PNP 2014-075

SUBJECT: Response to Request for Additional Information - Palisades - RR 4-17, Proposed Alternative, Request for Relief from Immediate ASME Code Flaw Repair of Service Water System Manual Valve MV-SW135 - MF3192

Response to Request for Additional Information - Palisades - RR 4-17, Proposed Alternative, Request for Relief from Immediate ASME Code Flaw Repair of Service Water System Manual Valve MV-SW135 - MF3192

Pin Hole Leak

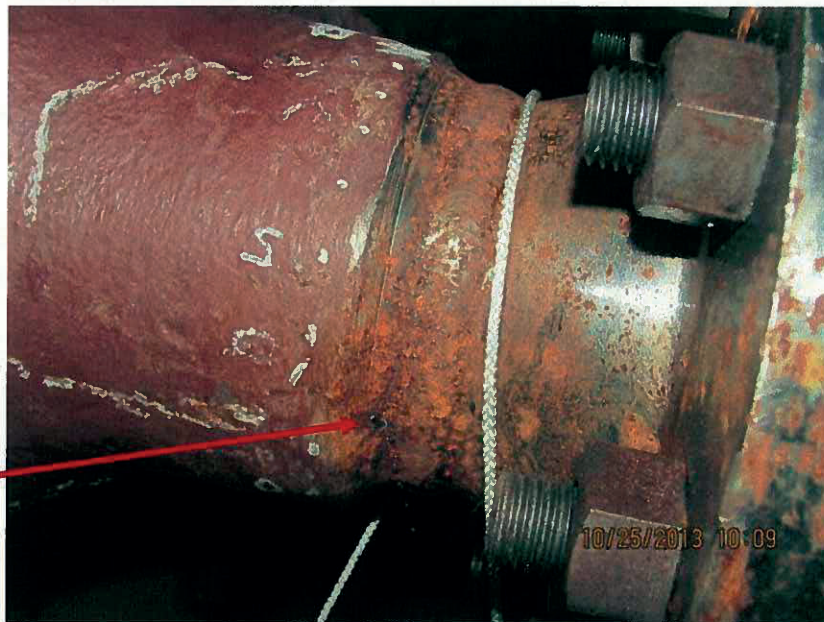
1. *Discuss the actual size of the pin hole in the MV-SW135 valve. Discuss the wall thickness at and around the pin hole.*

1. The size of the pin hole in service water system manual valve MV-SW135 was not measured or calculated, although, judging from its measured leak rate of 3.5 mL per minute, it was very small. The wall thickness in the vicinity of the leak was measured by ultrasonic testing (UT) at the time the leak was discovered on October 25, 2013. The pin hole was encompassed by weld inspection points AP01 and AQ01 and valve body inspection points AP02 and AQ02 (see UT examination records for the weld and the valve body in the operability evaluation in Attachment 3 of the relief request). The measured wall thicknesses at weld inspection points AP01 and AQ01 were 0.256 inches and 0.215 inches, respectively. The measured wall thicknesses at valve body inspection points AP02 and AQ02 were 0.672 inches and 0.692 inches, respectively. The minimum wall thickness measured in the vicinity of the pin hole was at weld

inspection point AO01, which was 0.102 inches (see UT examination records for the weld in the operability evaluation in Attachment 3 of the relief request).

UT thickness measurements were taken again on November 21, 2013 and on December 19, 2013. The table below provides the thickness measurements taken for these inspection points on these dates.

Date	Weld Inspection Point AP01	Weld Inspection Point AQ01	Valve Body Inspection Point AP02	Valve Body Inspection Point AQ02	Weld Inspection Point AO01
10/25/13	0.256	0.215	0.672	0.692	0.102
11/21/13	0.251	0.211	0.675	0.699	0.109
12/19/13	0.224	0.208	0.710	0.710	0.104
